ADDENDUM NUMBER ONE (1) TO THE PLANS AND SPECIFICATIONS FOR:

City of Port Aransas Public Safety Center Port Aransas, Texas Project No. 18.22

ADDENDUM

DATE: May 31, 2023

PLAN - AREA 'B'

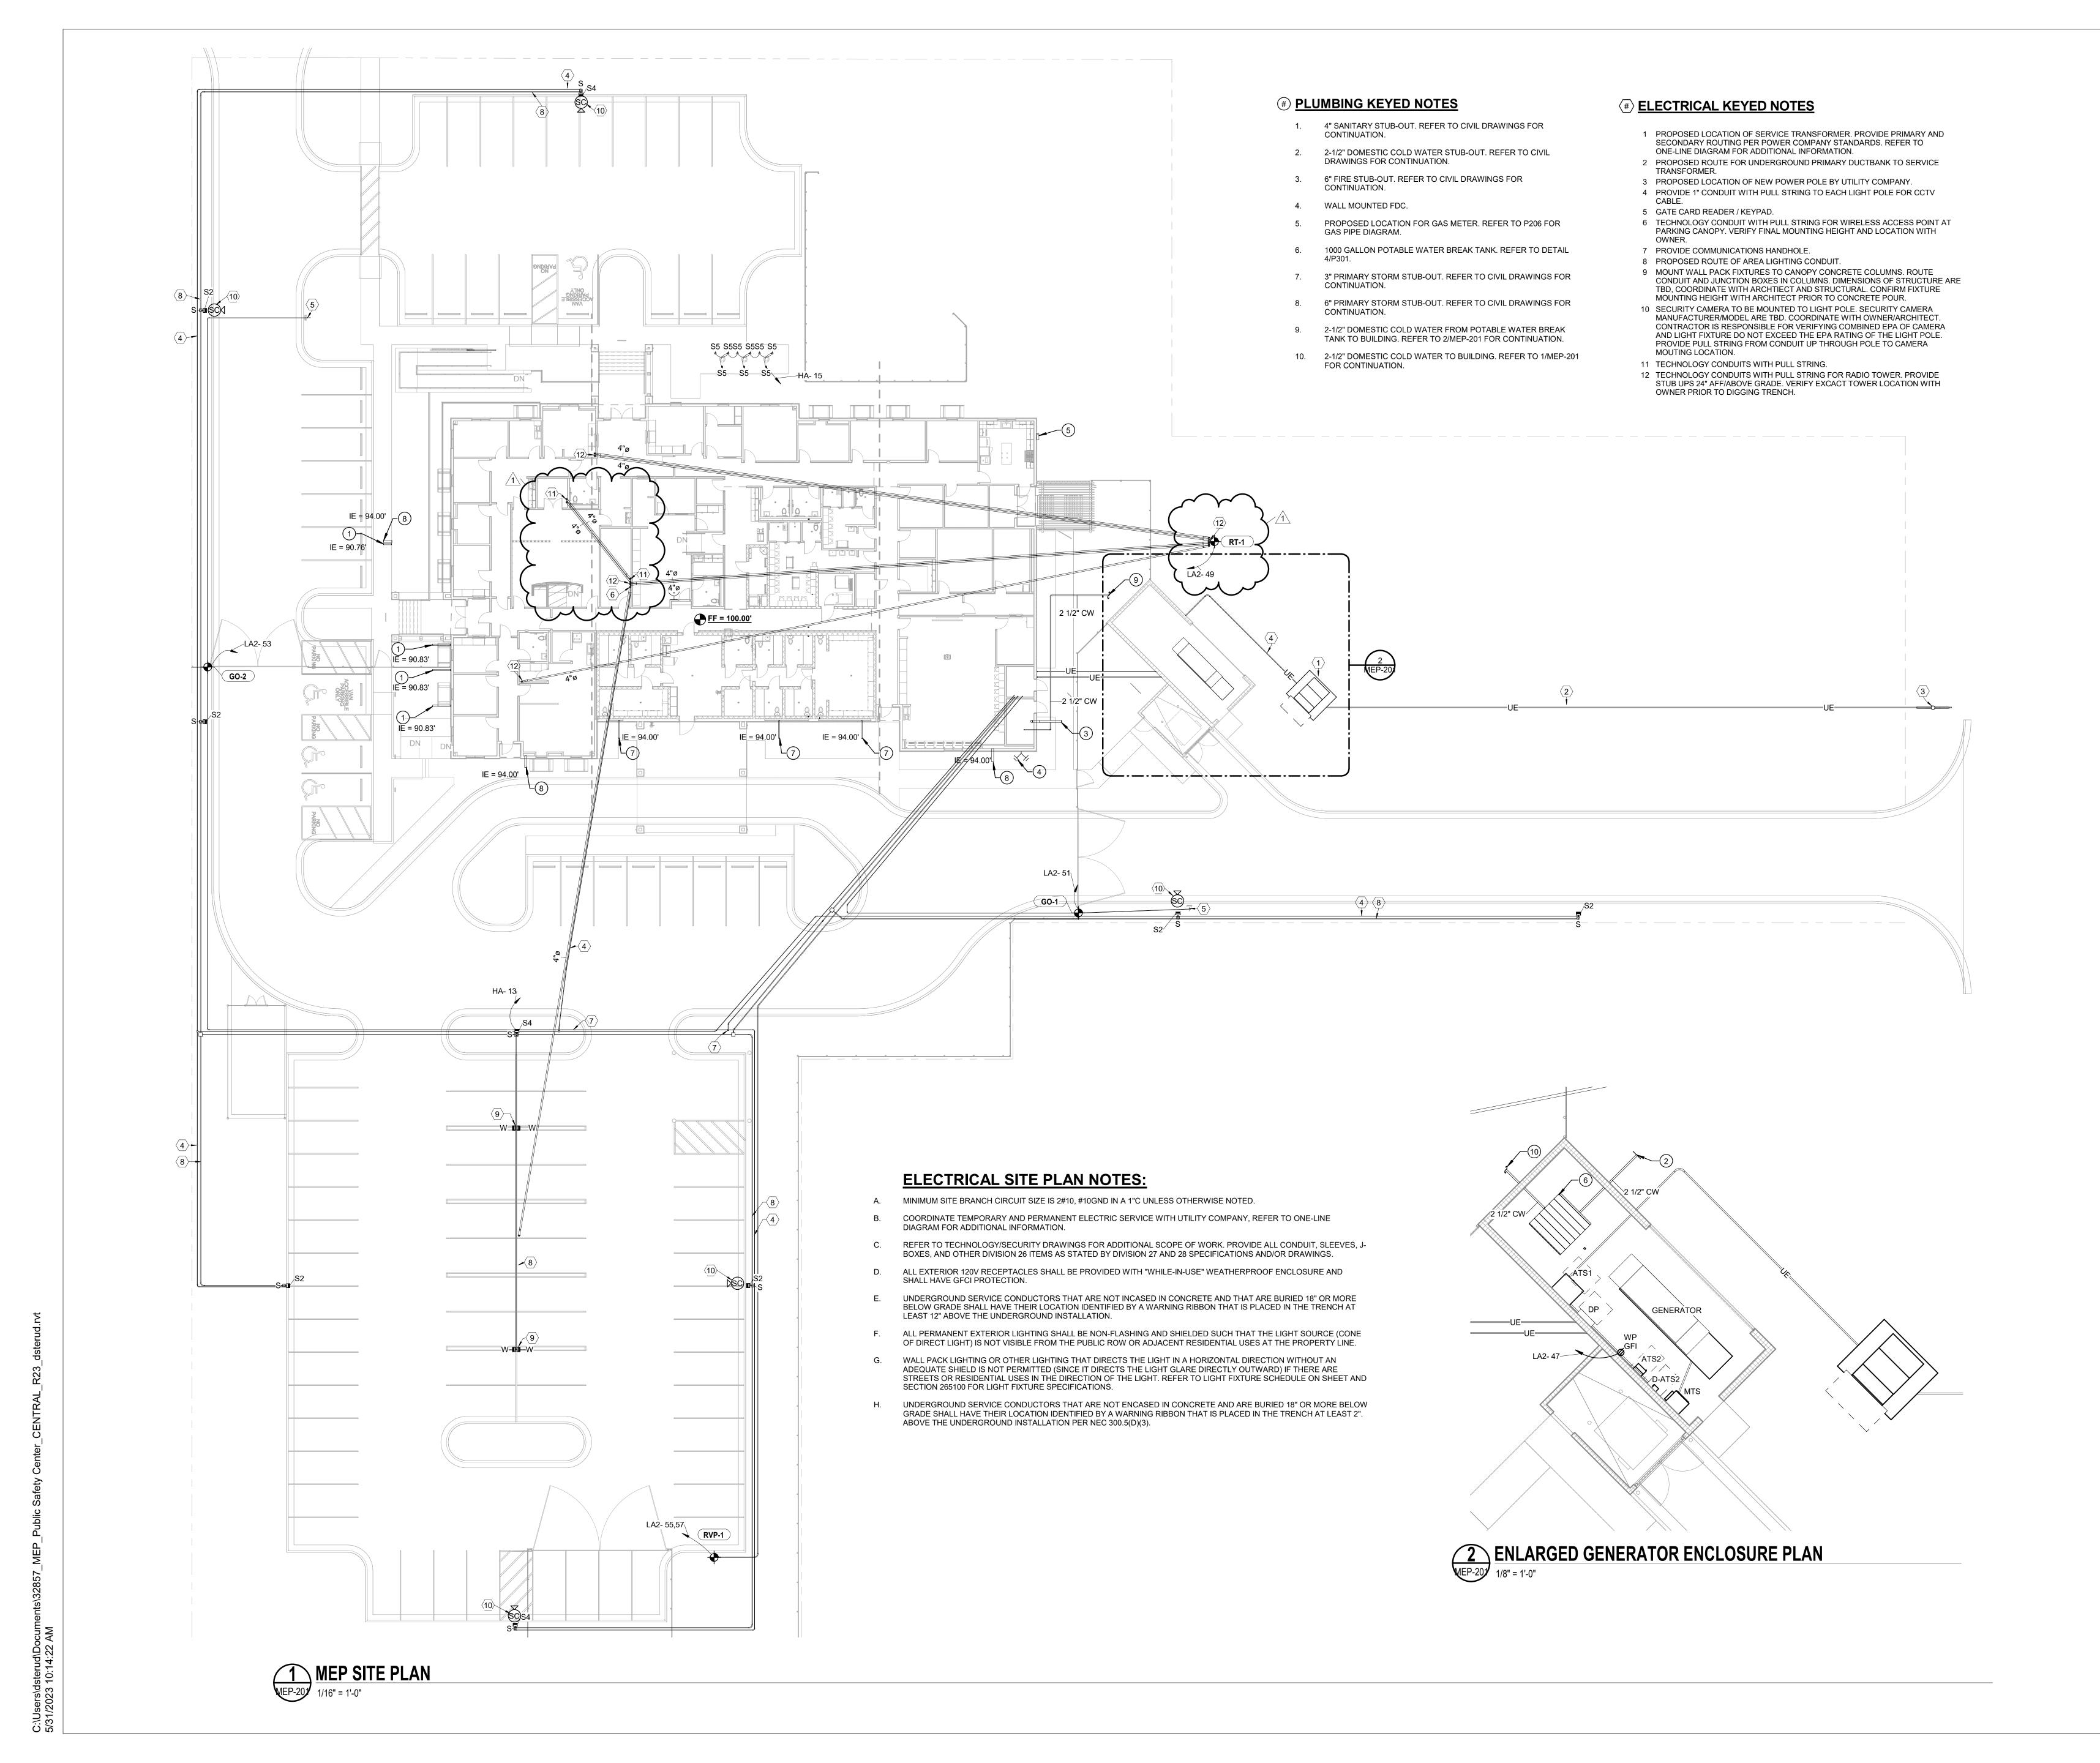
- Delete this sheet in its entirety and replace with sheet A-406, included within this addendum.
- 2. Revised ceiling in Lobby B101.
- 3. Revised ceiling section.

MEP SITE PLAN

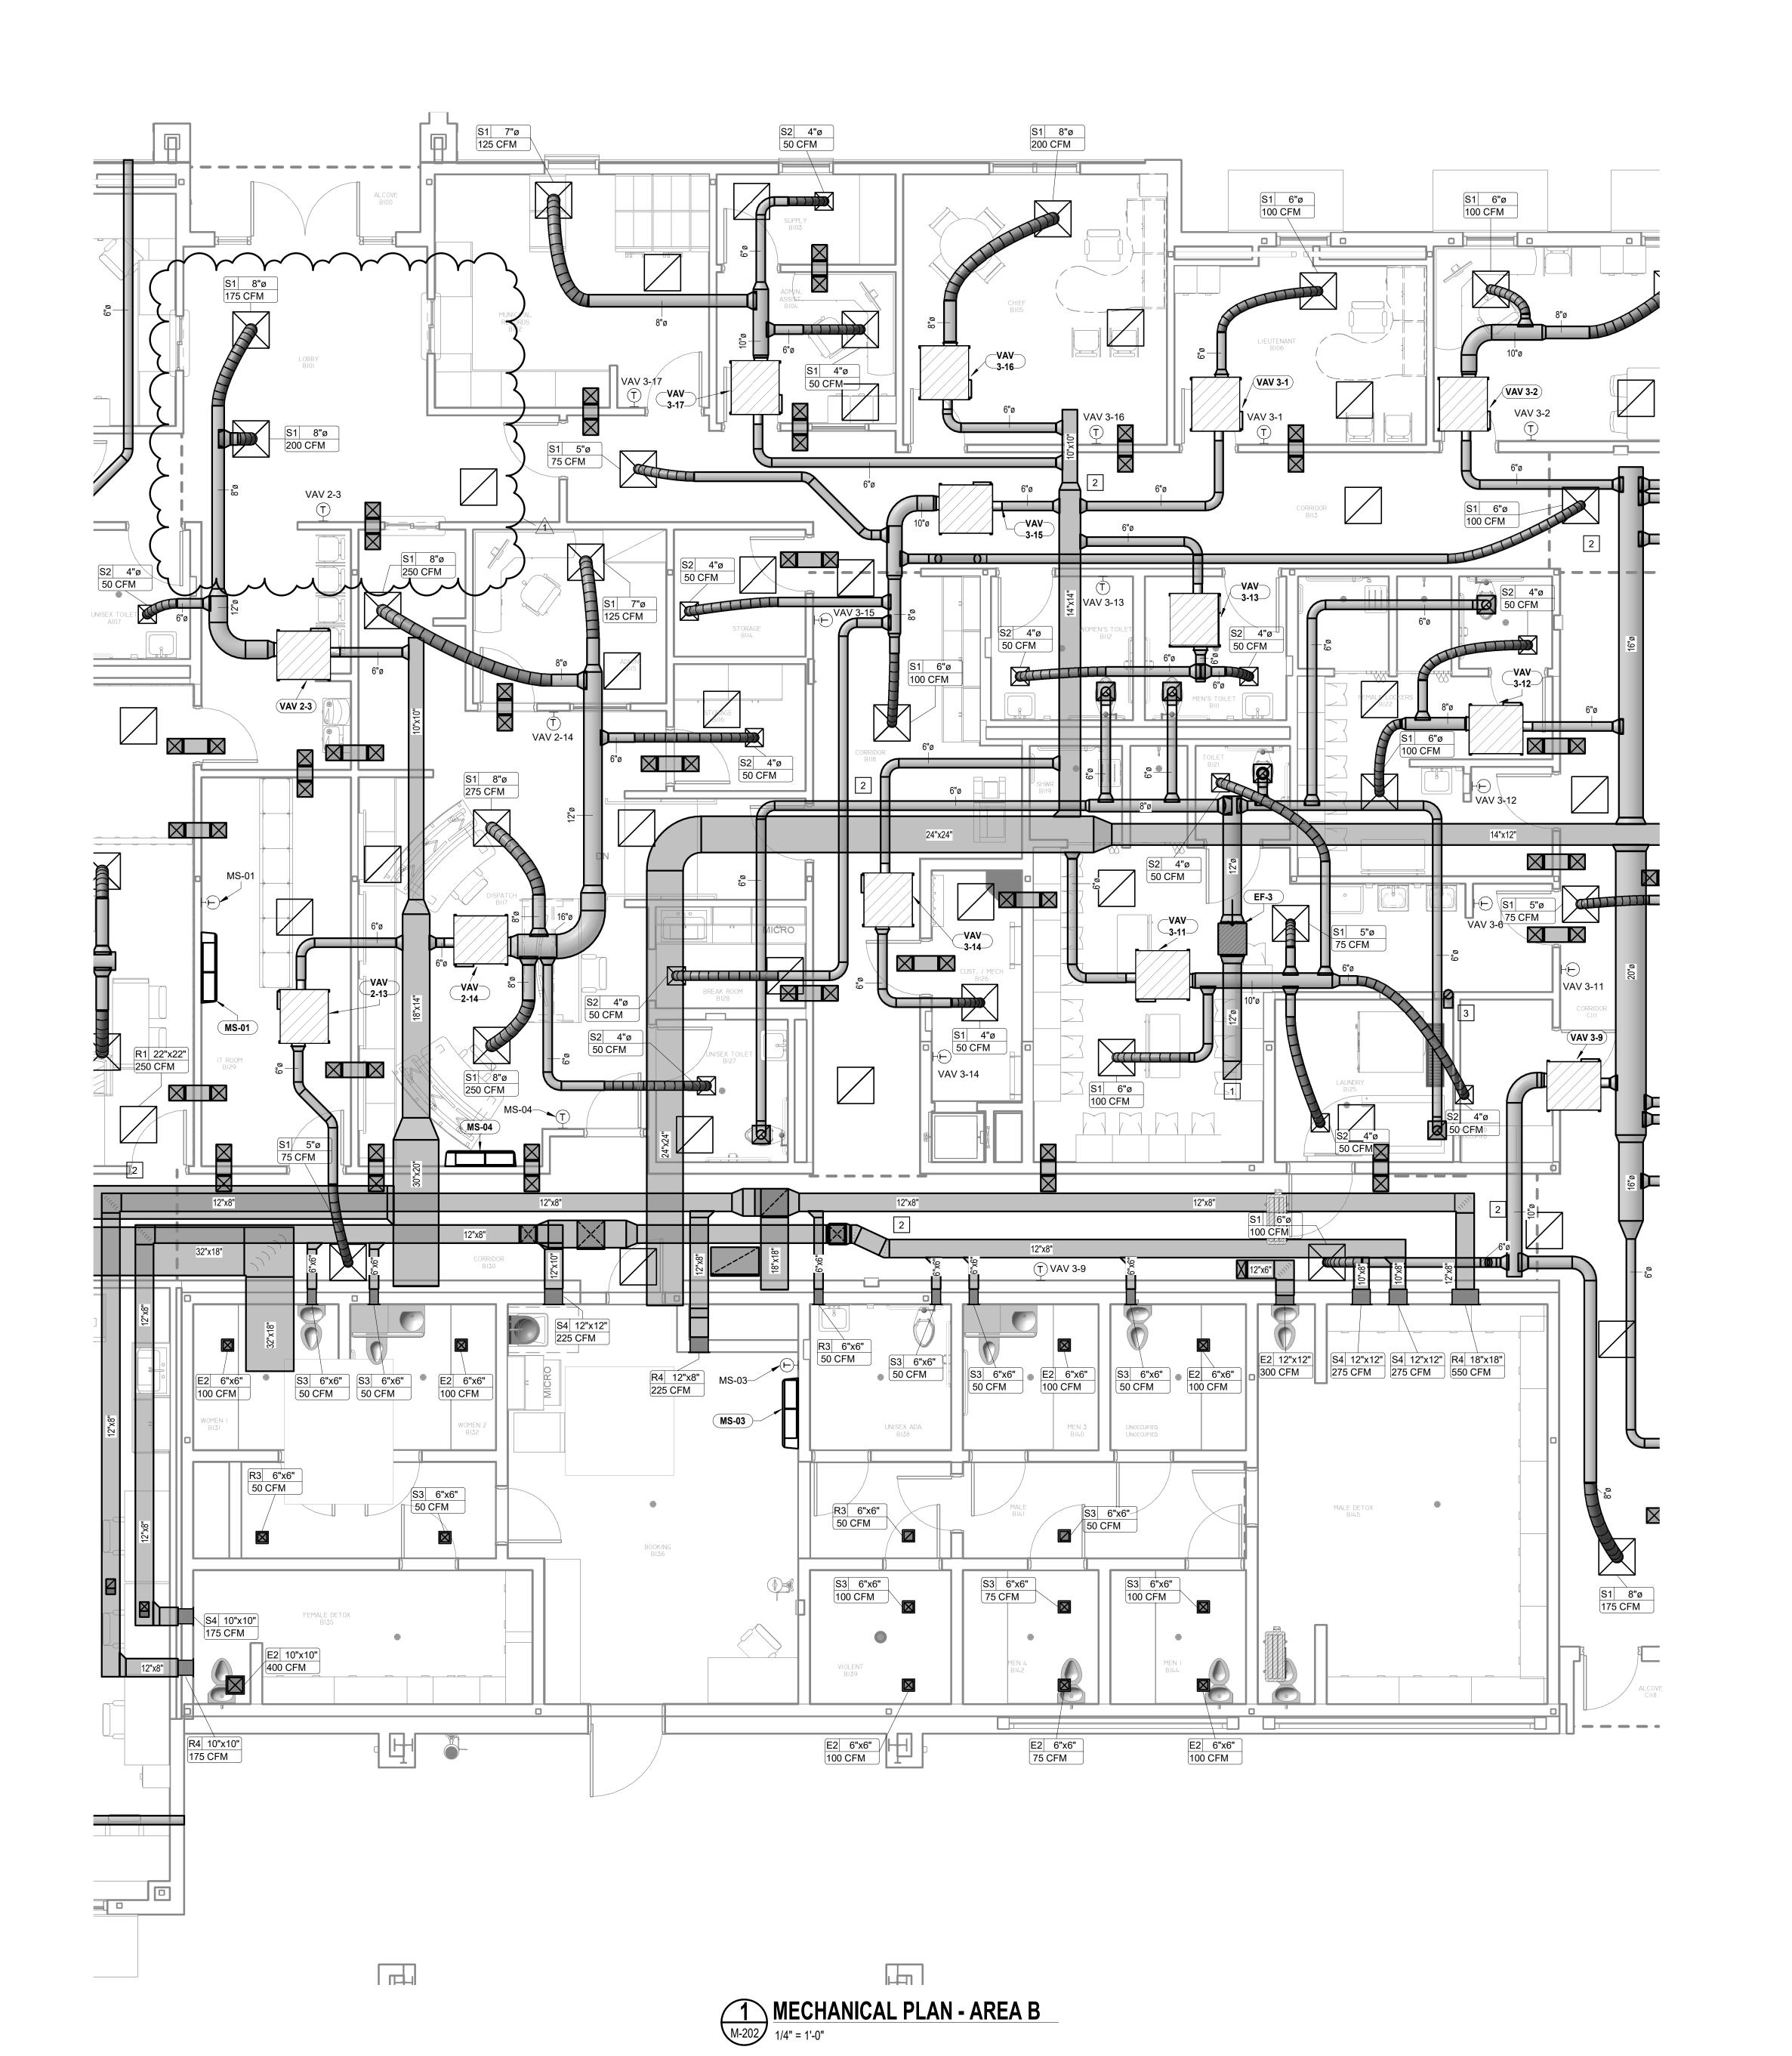
A) Re-submit sheet due to keyed note glitch.

Sheet Title: **ELECTRICAL LIGHTING PLAN -AREA B**

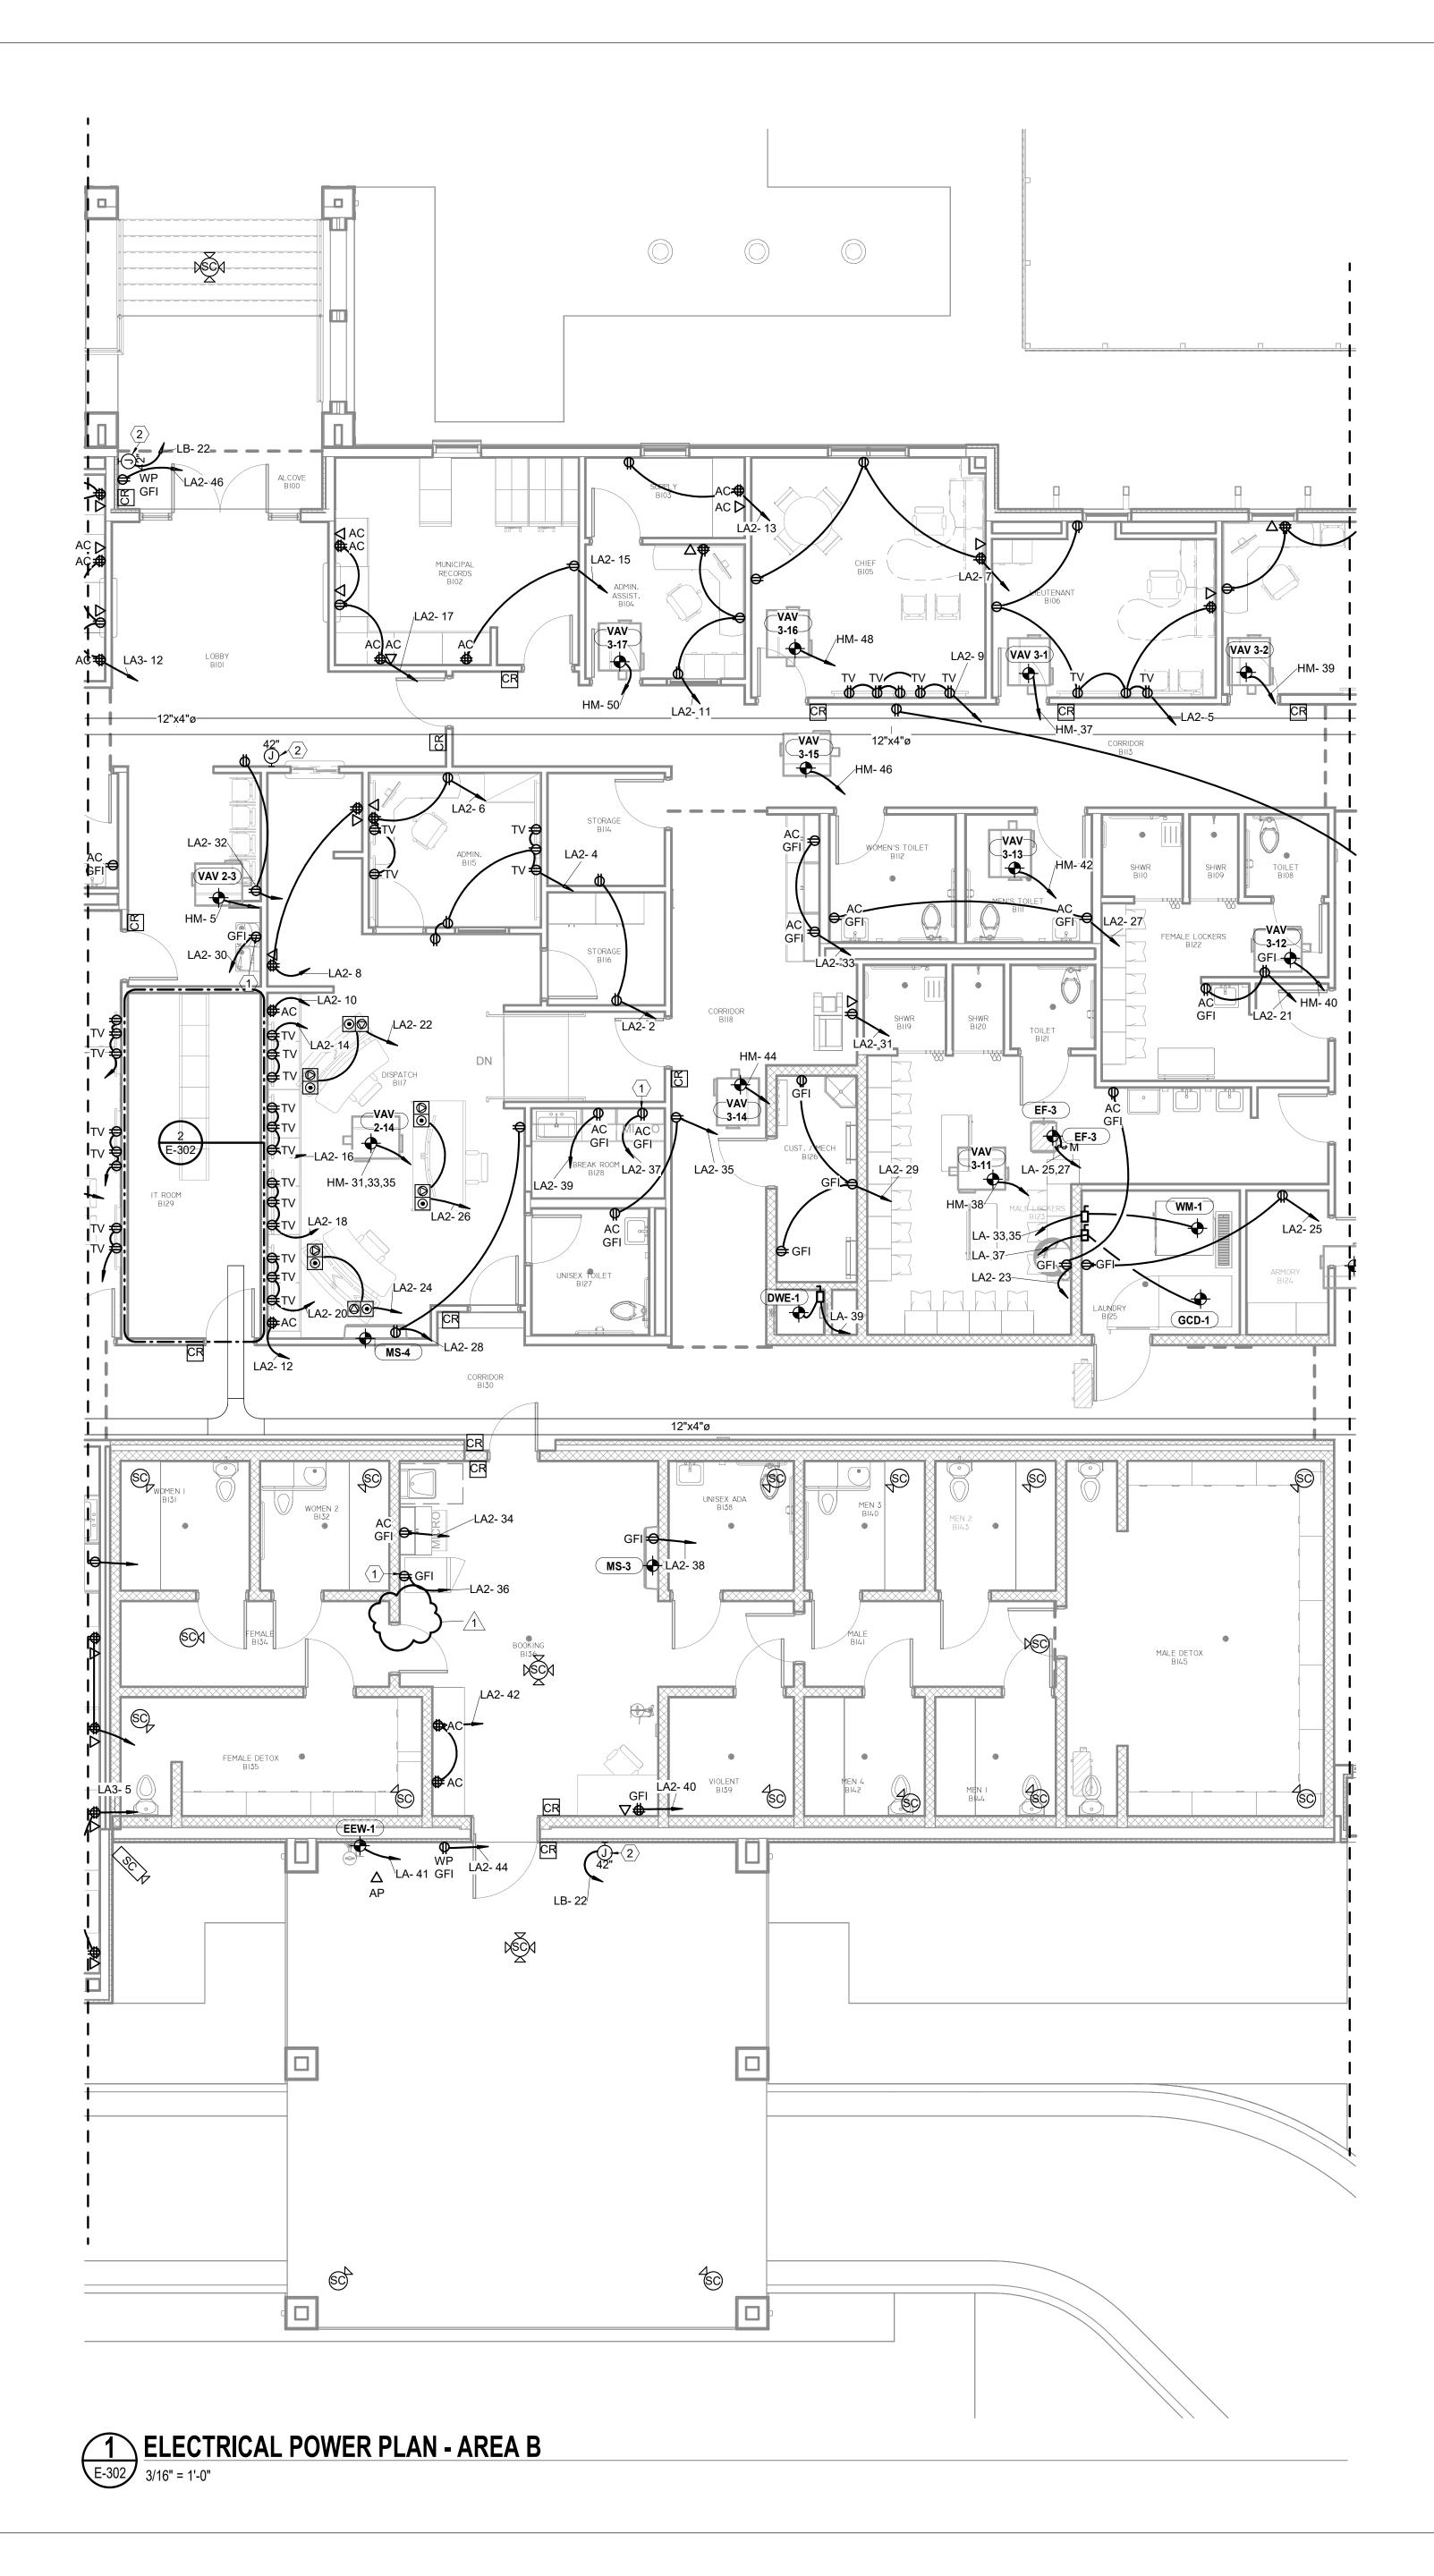
A) Adjust light fixtures in lobby B101 due to ceiling change.
